DART AEROSPACE LTD	Work Order:	99882
Description: Crosstube Assembly (205/212 High Aft)	Part Number:	D212-664-241
Inspection Dwg: D212-664-241 Rev: D		Page 1 of 2

DRAWING NO. D212-664-241	TITLE CROSSTUBE ASSY (205/212 HI AFT)	REV. D	DART AEROSPACE LTD ENGINEERING ORDER		D.E.O. NO. D212-664-241-D-1	SHEET NO. SHEET 1 OF 2	SCALE NTS
DRAWN	CHECKED	MFG. APPR.	APPROVED	DE APPR.			
DATE 11.04.07	DATE 11.04.11	DATE 11.04.12	DATE 11/04/12	DATE 11.04.12

ADD AN INSPECTION WINDOW TO UNDERSIDE OF CROSSTUBE.

REPLACE MAGNOBOND WITH PROSEAL.

**D212-664-241/-241B
ASSEMBLY DETAIL**

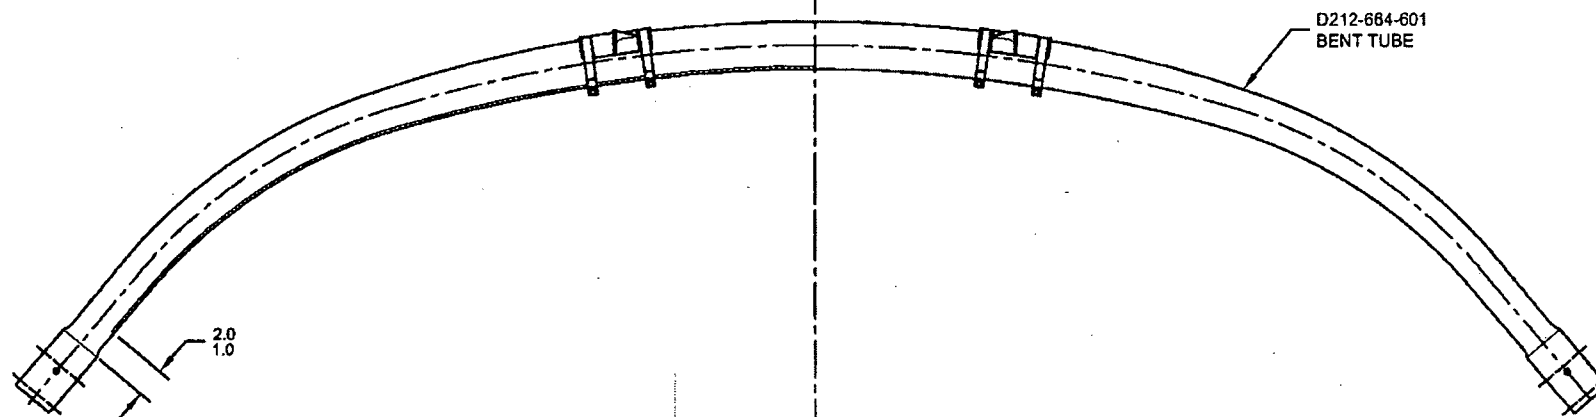
PURPOSE:

NOTES 2 OF SHEET 1 IS AMENDED AS FOLLOWS:

IS:

WAS:

MASK AREA PRIOR TO PAINTING,
REMOVE MASKING AFTER PAINT
AND APPLY CLEAR COAT
